Final Environmental Impact Statement

**REMEDIAL ACTIONS AT THE FORMER  
CLIMAX URANIUM COMPANY  
URANIUM MILL SITE  
GRAND JUNCTION, MESA COUNTY,  
COLORADO**

DECEMBER, 1986

FIGURE 3.6  
TYPICAL CROSS-SECTION - TWO ROAD ALTERNATE DISPOSAL SITE

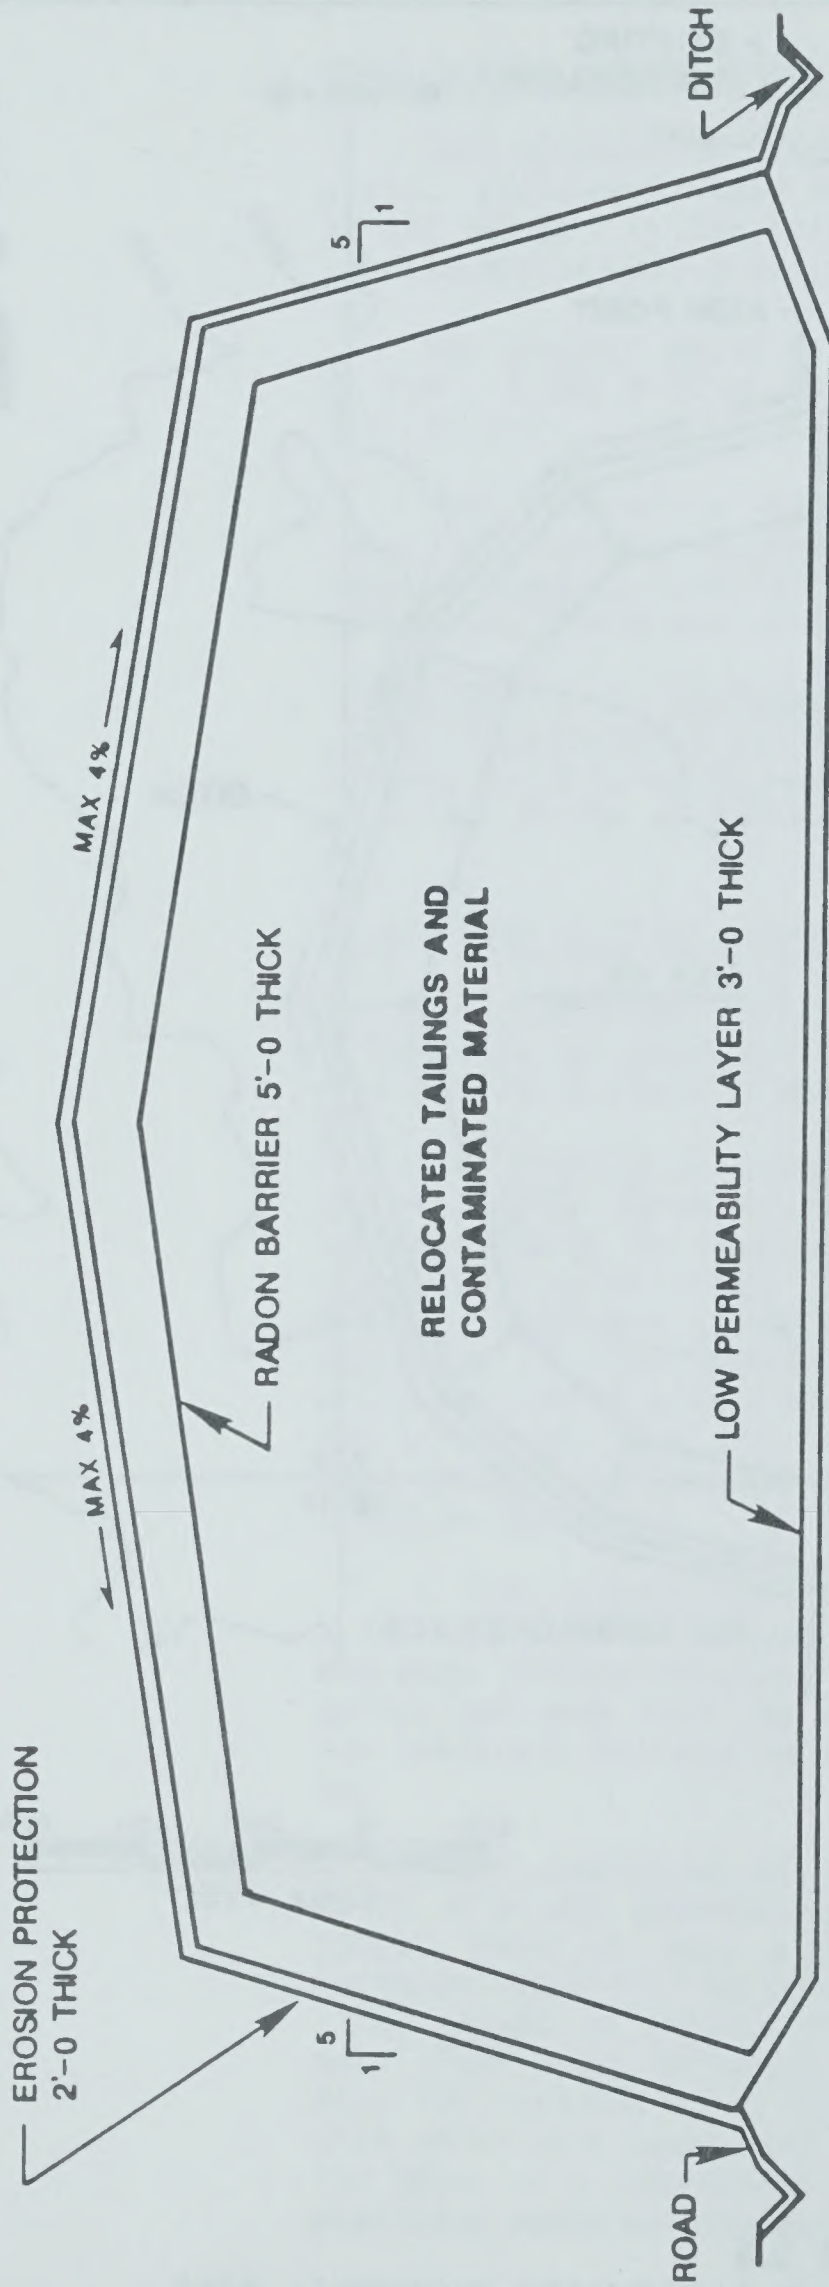
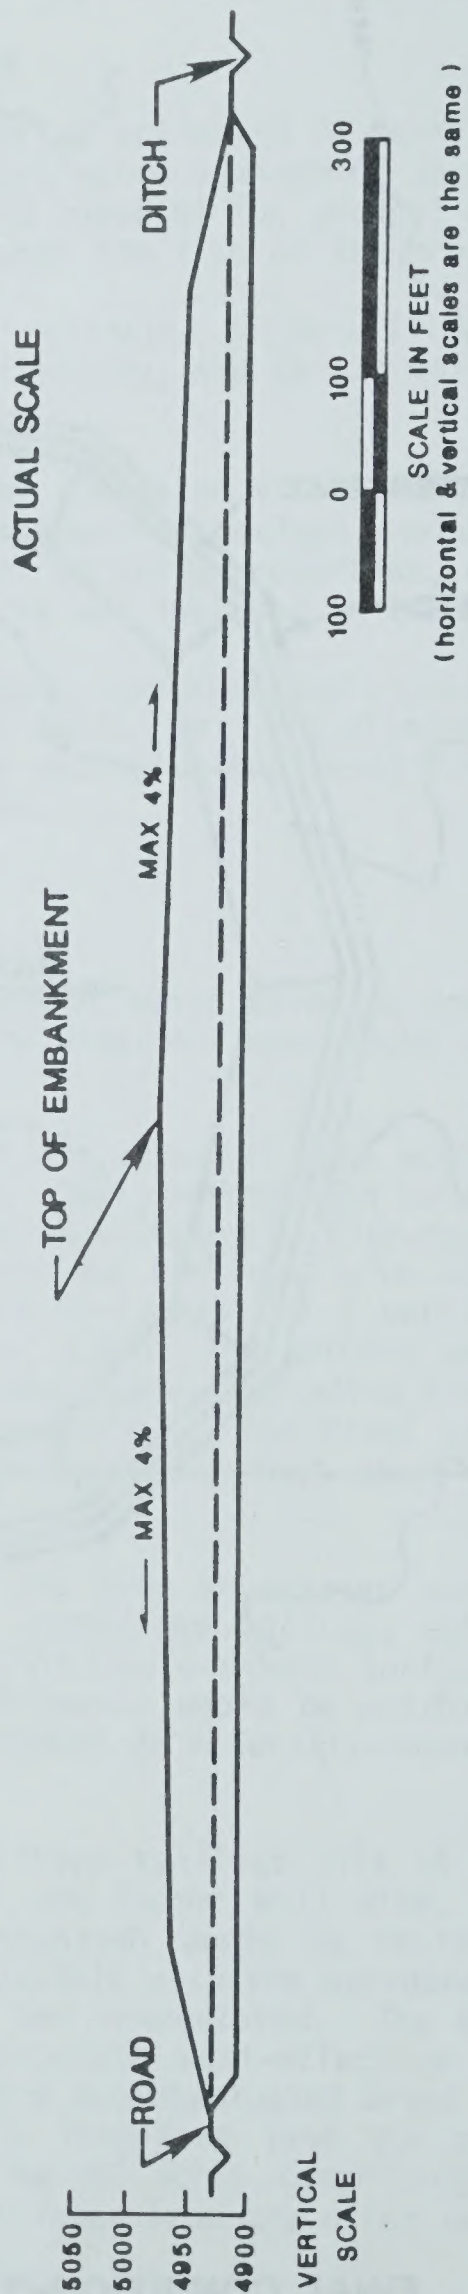
- 30 38 6.4.22 8th bullet - See comment #26.
- 31 39 6.4.24 See comment #27.
- 32 42 Figure 3.6 6.4.25.6 See comment #29.
- 33 46 6.21.3 1st sentence - See comment #2.

**FIGURE 4.4**  
**CHENEY RESERVOIR ALTERNATE DISPOSAL SITE**

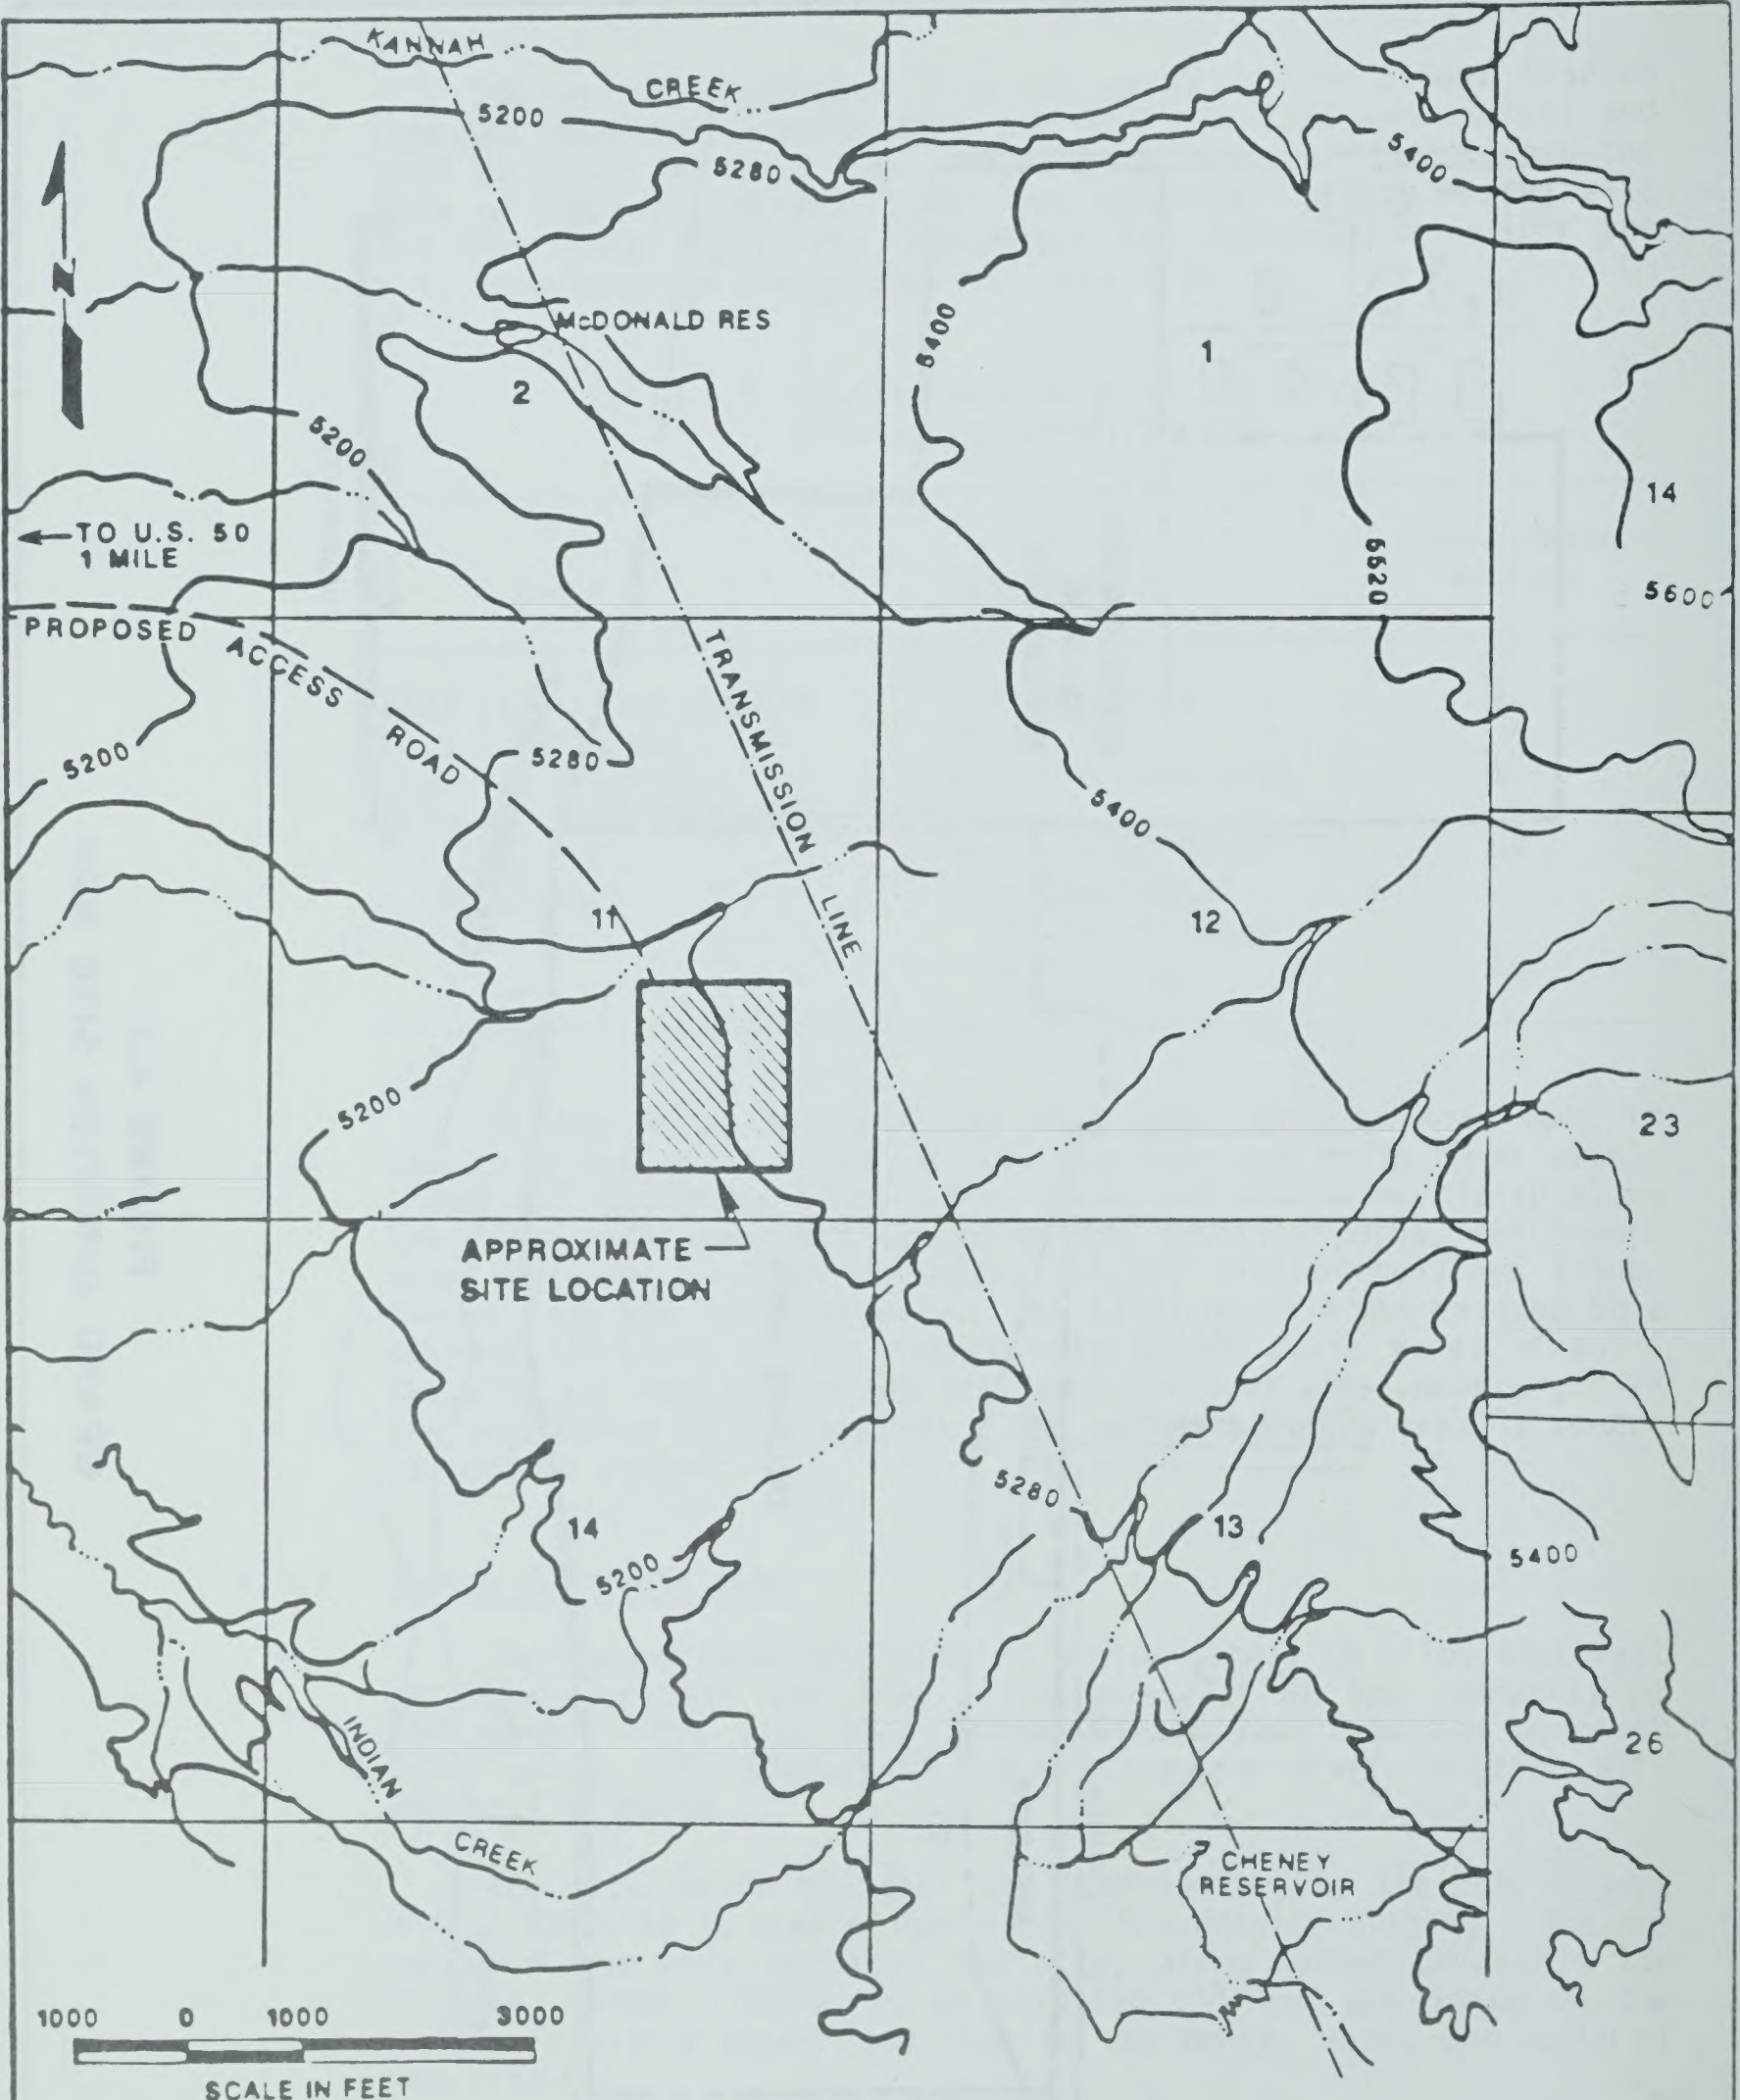
- 39 53 6.21.3 6.11.11 See comments #2 and #9.
- 40 60 Figure 4.4 6.24.7 Township and Range of the Cheney Reservoir site should be indicated.
- 41 62 Figure 4.5 6.24.7 Township and Range of the Two Road site should be indicated.

Agreed. Figures 4.4 and 4.5 have been revised.

FIGURE 4.8  
GENERALIZED CROSS-SECTION OF THE GEOLOGIC STRUCTURE  
IN THE GRAND JUNCTION AREA

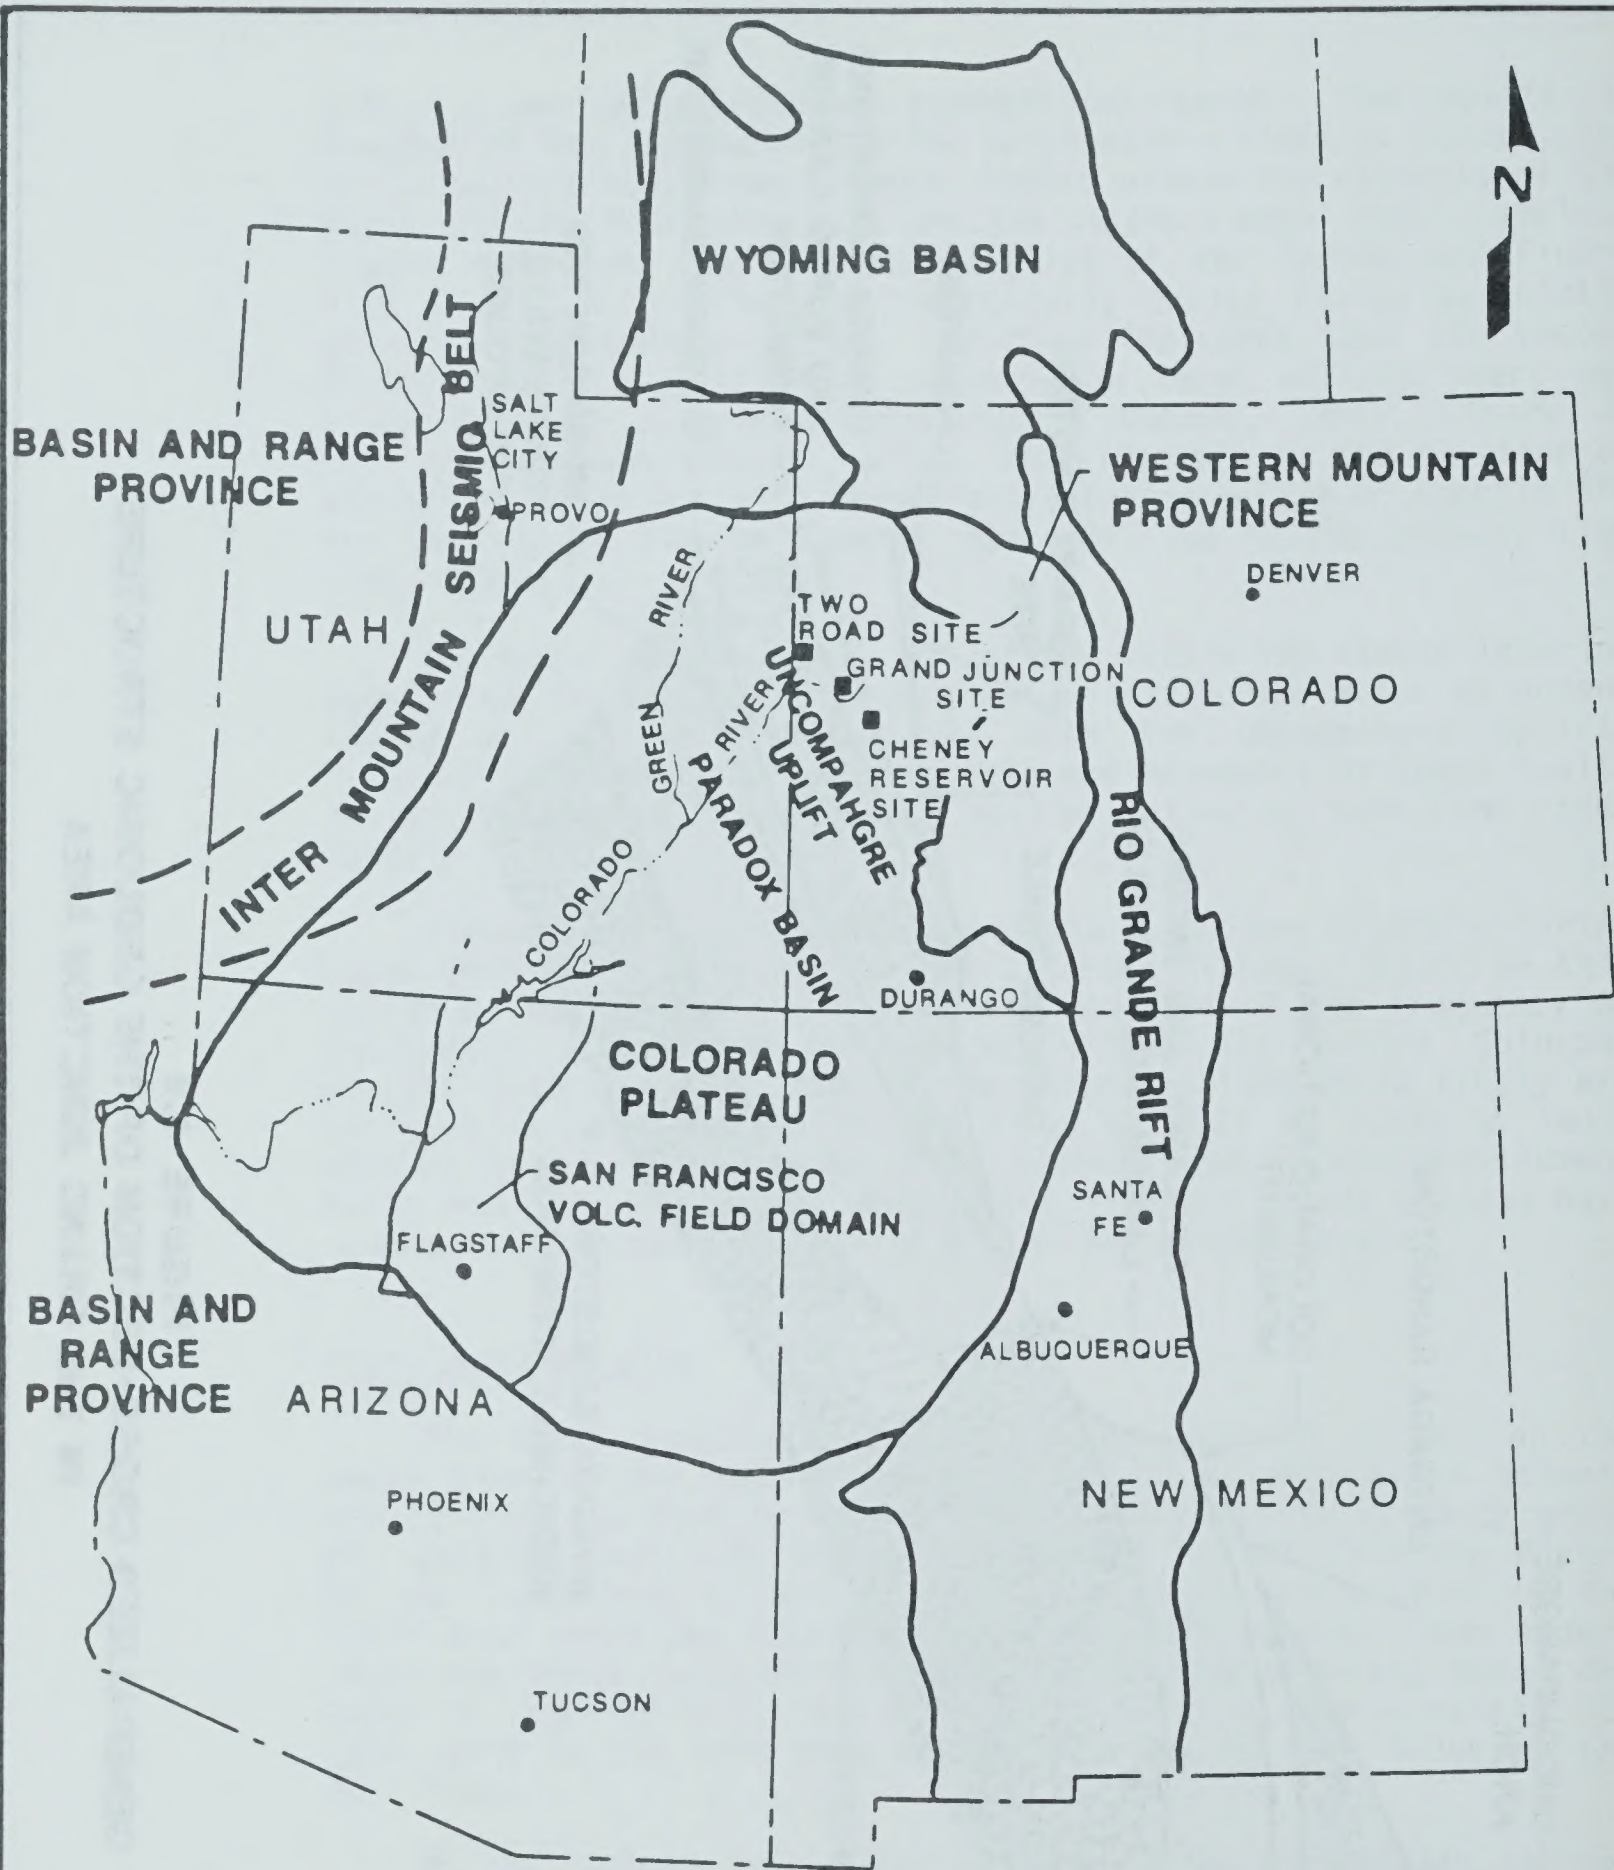
The pattern for the Precambrian schists, gneiss, etc., on Figure 4.8 is appropriate for sedimentary rocks only, not metamorphics. Standard patterns for metamorphics are available and should be used (25).

- 6.4.19 Page 61, 4.2.4. The number of cubic yards of borrow material should be included here.
- 6.19.1 Page 73, Figure 4.8. The pattern for the Precambrian schists, gneiss, etc, is appropriate for sedimentary rocks only, not metamorphics. Standard patterns for metamorphics are available and should be used.

Agreed. Figure 4.8 has been revised.
